ADDENDUM #1 – 2-2-17

PROJECT #: 21627

PROJECT: New Group Home Remodeling Marathon County
5475 North 28th Ave, Village of Brokaw, WI

1 **FLOOR PLAN**
A1.0 1/4" = 1'-0"

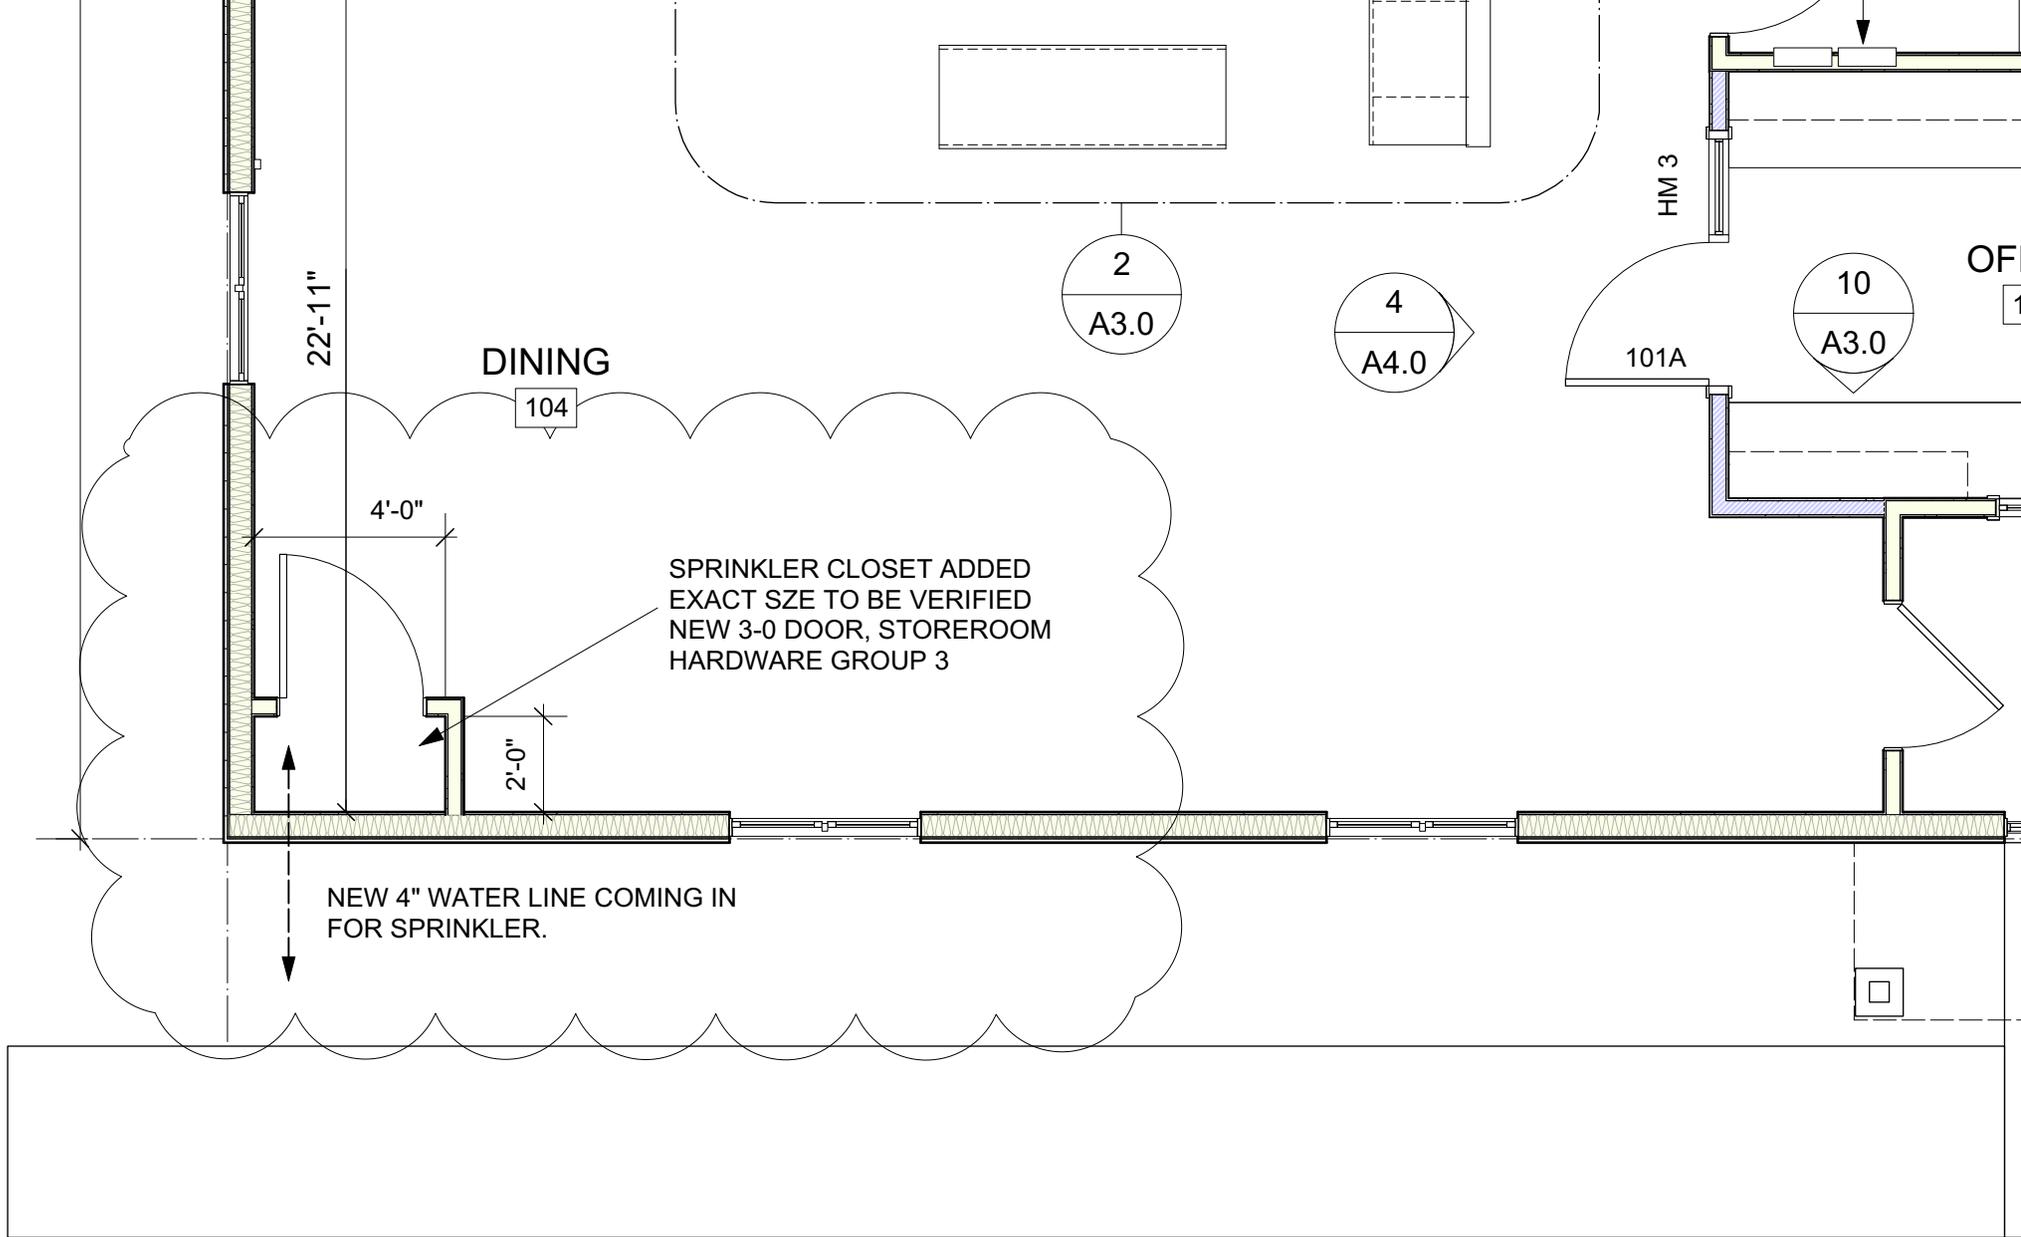
- A1.0 Sprinkler Closet in NW corner
- A2.0 Reflective Ceiling Revision
- A4.0 Revised Door Schedule

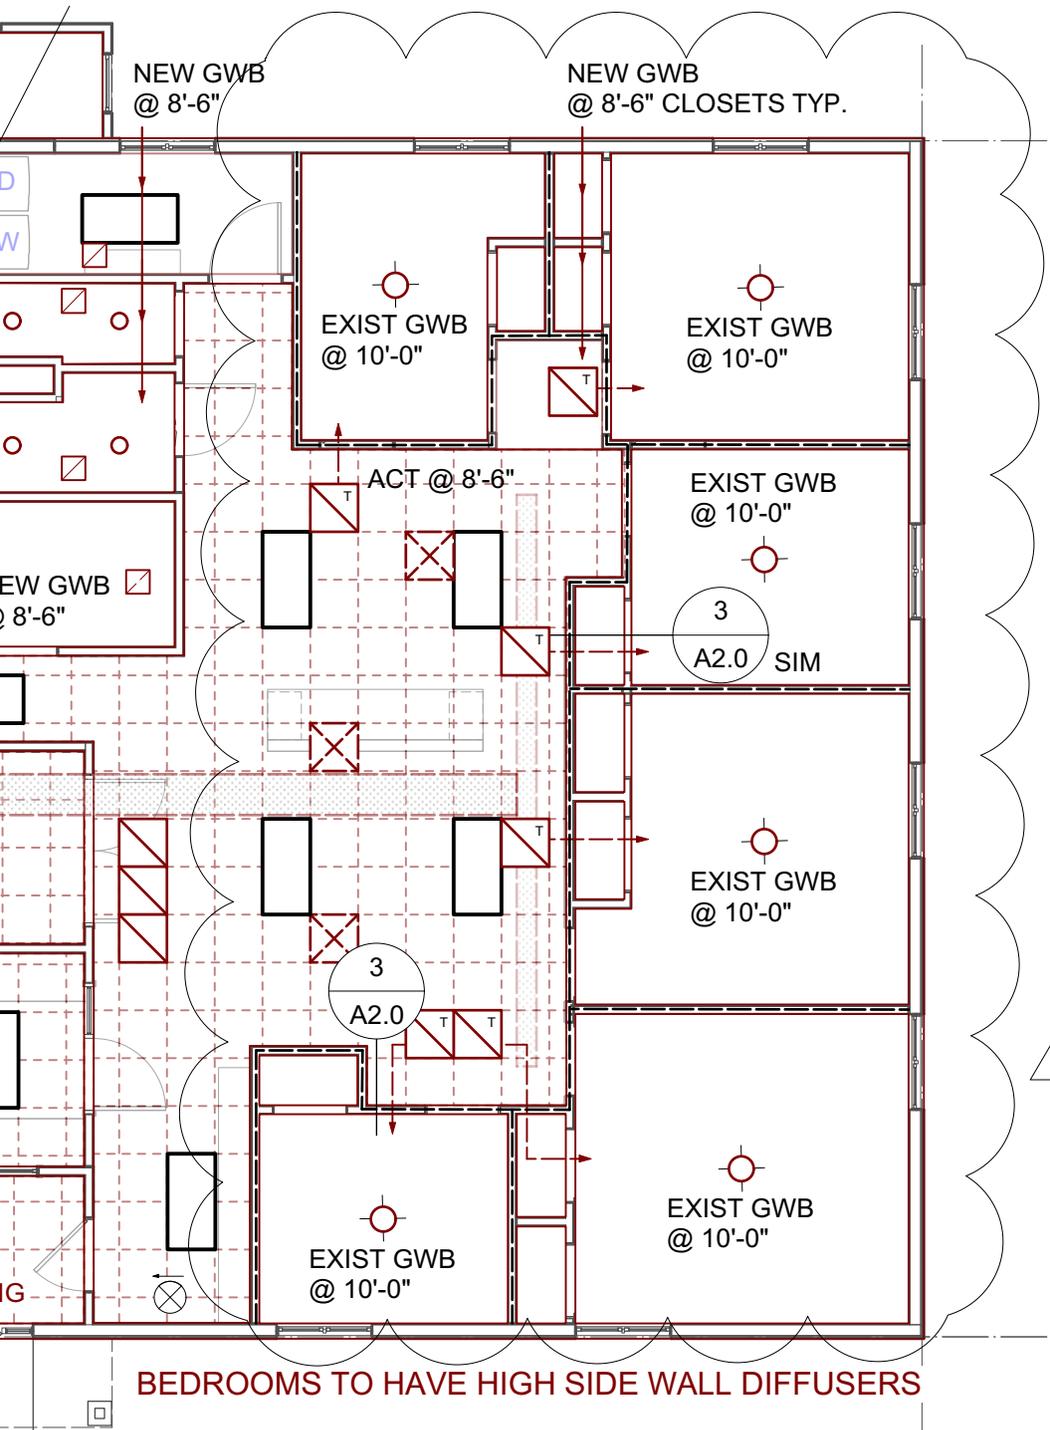
2. Room Finish Schedule, Rm 111 Staff Toilet, Rm 115 & 116 shower, and 117 Laundry, Base to be CT in Lieu of wood.
3. Room Finish Notes, Rooms 118 – 123 bedrooms, noted to be ½ hour rated, can not be reduced to ½ hr so will stay 1 hr rated walls, see revised Reflective Ceiling Plan attached showing locations.

- A2.0 - 1. Reflective Ceiling Plan revised to show location of 1 hr walls at Bedrooms. See attached plan.
- A4.0 - 1. Frame types, HM 4 and HM 5 should be reversed, shown opposite on the plans.

* WALL TYPES BETWEEN BEDROOMS & CENTER SPACE TO BE 1 HR FIRE RATED CONSTRUCTION
5/8" FIRE CODE GWB ON EA SIDE TO DECK, TAPED AND FINISHED, 2 X 4 WOOD STUDS 16" O/C
UL DESIGN U305
